JAMES A. FITZPATRICK NUCLEAR POWER PLANT

AMENDMENT TO FACILITY OPERATING LICENSE

Amendment No. 123  
License No. DPR-59

SAFETY EVALUATION BY THE OFFICE OF NUCLEAR REACTOR REGULATION

FIGURE 6.1-1

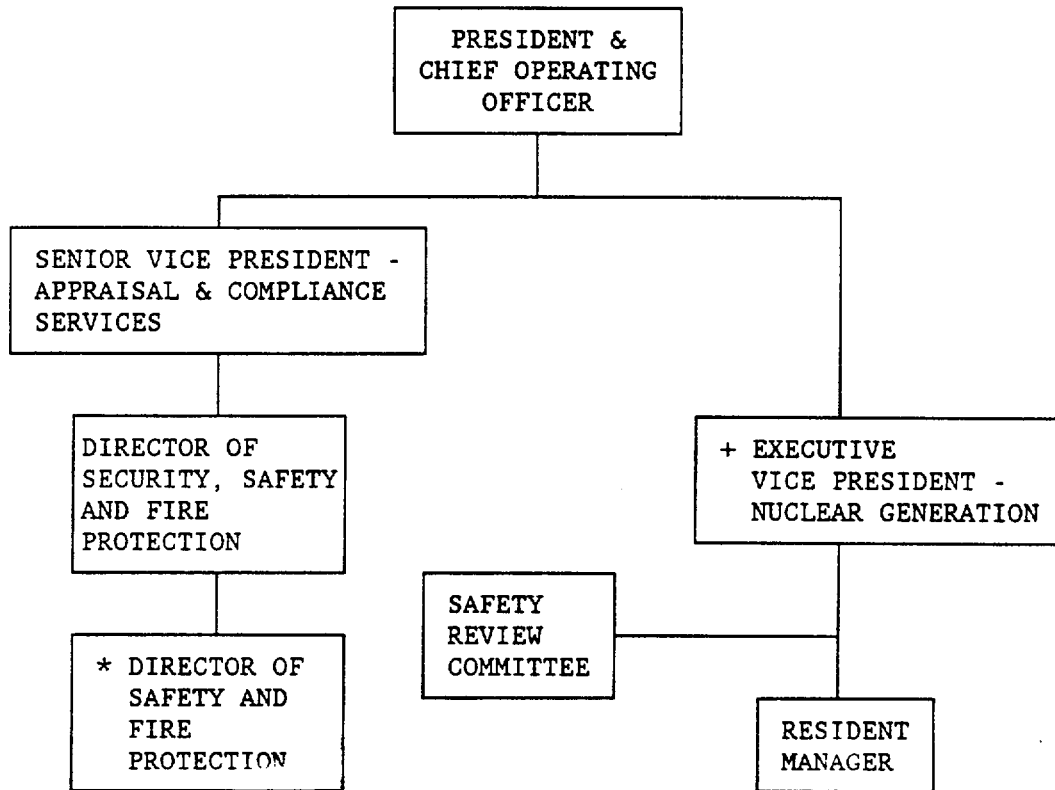
The proposed change to TS Figure 6.1-1 reflects elimination of the Engineering and Design Department by deleting the positions of: (1) First Executive Vice President - Operations, and (2) Executive Vice President and Chief Engineer - Engineering and Design. The proposed change to TS Section 6.5.2.2 removes the Vice President - Design and Analysis from membership on the Safety Review Committee (SRC) since the position will no longer exist.

The Engineering and Design Department was divided into nuclear and non-nuclear analytical engineering and design groups and the support staff personnel were reassigned to the Nuclear Generation and System Operations Departments. These changes, therefore, allow the grouping of similar and interdependent activities, affording each of the departments more effective control of the key resources required to accomplish its tasks. The Nuclear Generation Department will now be responsible for all operations, engineering, and construction of the PASNY nuclear power plants. The position of First Executive Vice President - Operations has been eliminated to reduce the number of management levels

without compromising effectiveness. However, the responsibility and functions have been divided between the Executive Vice President - Nuclear Generation and Executive Vice President - System Operations.

The proposed changes to the TS are purely administrative in nature in that they reflect the corporate reorganization only. Thus the changes will have no effect on plant operation as described in the FSAR and are considered satisfactory.
